YARRA CITY COUNCIL
Internal Development Approvals Committee
Agenda – Part 1 of 2

Item		Page	Rec. Page
1.1	PLN19/0312 - 194 Bridge Road, Richmond - Development of the land for partial demolition, construction of a five storey extension to the existing building (plus basement) and a reduction of car parking requirements of the Yarra Planning Scheme	5	34

Ward: Melba
Proposal: Development of the land for partial demolition, construction of a five storey extension to the existing building (plus basement) and a reduction of car parking requirements of the Yarra Planning Scheme in association with a food and drink premises and medical centre
Existing use: Shop
Applicant: Tract Consultants
Zoning / Overlays: Commercial 1 Zone
 Heritage Overlay (Schedule 310)
 Design and Development Overlay (Schedule 5)
 Design and Development Overlay (Schedule 21 -Precinct 1)
Date of Application: 16 May 2019
Application Number: PLN19/0312

Above: Area of existing building to be removed shown hatched in red

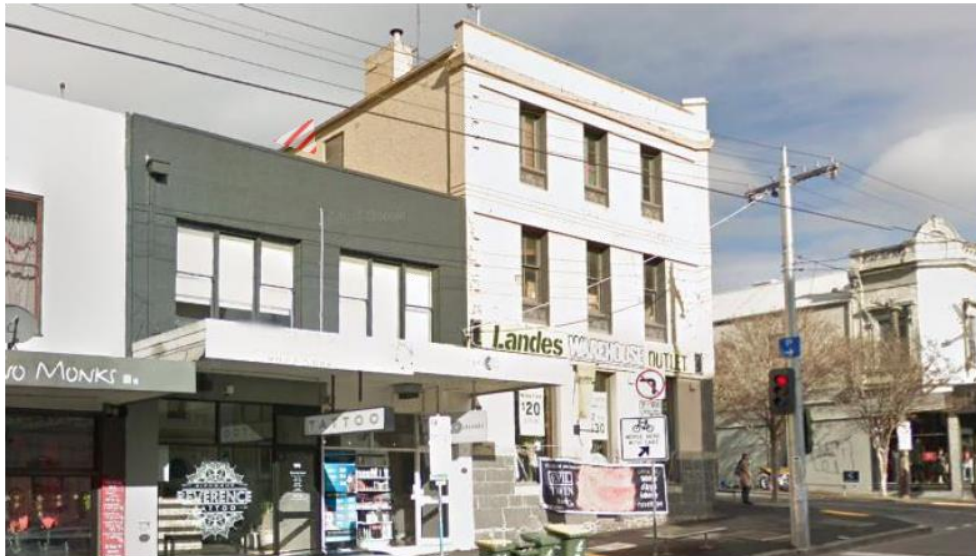
85. The Heritage Advisor is also not supportive of the removal of the south-eastern corner of the existing three storey roof form, citing the individually significant grading of the building justifies the retention of the roof in its entirety. Figure 8 shows the original roof has been significantly modified (with an ornate roof vent feature being originally present), and as such the fabric itself is not of significance. Further as this part of the roof is only visible on oblique views from the east above the non-ornate side wall, it is not considered to be a contributory factor to the heritage significance of the building (particularly as its roof is not visible above the existing parapets when viewed behind the ornate Bridge Road and Waltham Street principal heritage façades). For these reasons, the proposed demolition of this section of the roof is considered acceptable.

Above: Rough estimate of sightline from opposite the site in Bridge Road. Suggested setback from Bridge Road shown dotted in red.

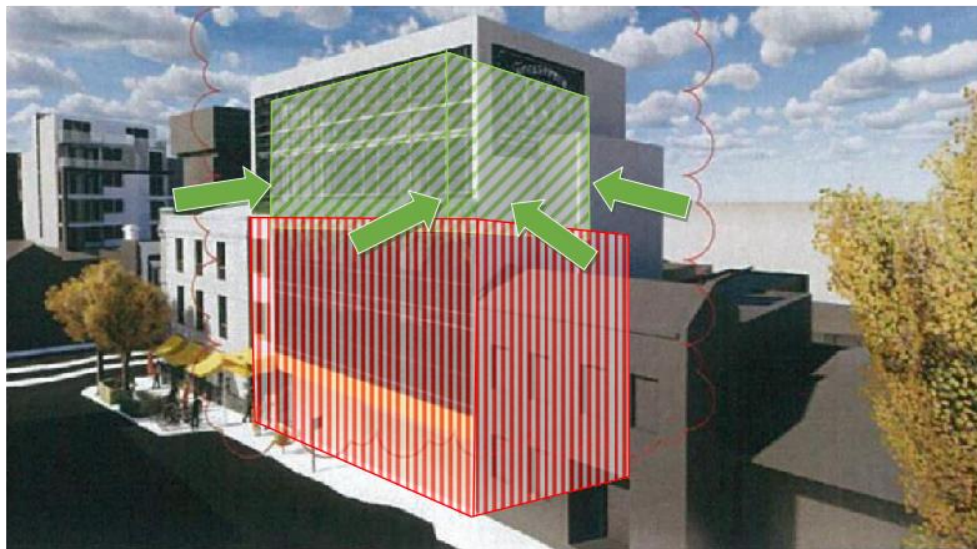
95. Council's Heritage advisor recommended a 2m setback to level 3 and a further increased setback to level 4 to Waltham Street and an increased setback of the upper levels to the southern residential interface. The Urban Design Unit recommended a 3m setback to levels 3 and 4 to Waltham Street and a further increased setback of these levels to the southern boundary. The sketch plans responded positively to these recommendations and include a 2.15m setback to levels 3 and 4 to Waltham Street and an increased 1.5m setback (to a total maximum of 3.4m) to the southern boundary.

96. These increased setbacks have successfully addressed the visual bulk concerns to the upper levels. Council's Heritage Advisor reviewed the amended sketch plans and supported the 2.15m setback to level 3 but recommended a further setback to Waltham Street to level 4 and an increased 3m setback to levels 3 and 4 to the southern boundary (i.e. total maximum of 4.9m) in lieu of the increased 1.5m setback.

Figure 7: Details of window reveals within existing endorsed plans to be reinstated via condition

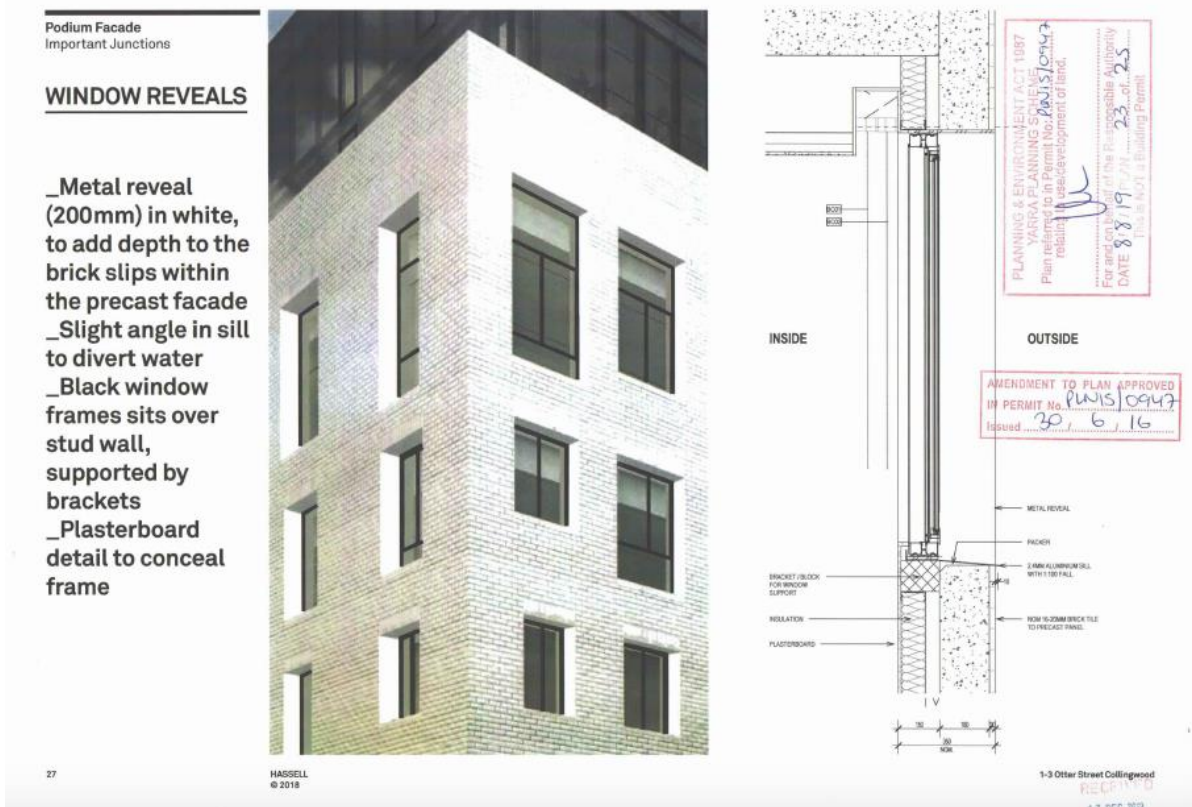
173. The window framing also has not been modified from the current endorsed scheme. It is noted, however, that details of the window reveals are no longer shown as provided within the current endorsed plans (Figure 7) and therefore a window strategy for the podium is to be provided via condition.
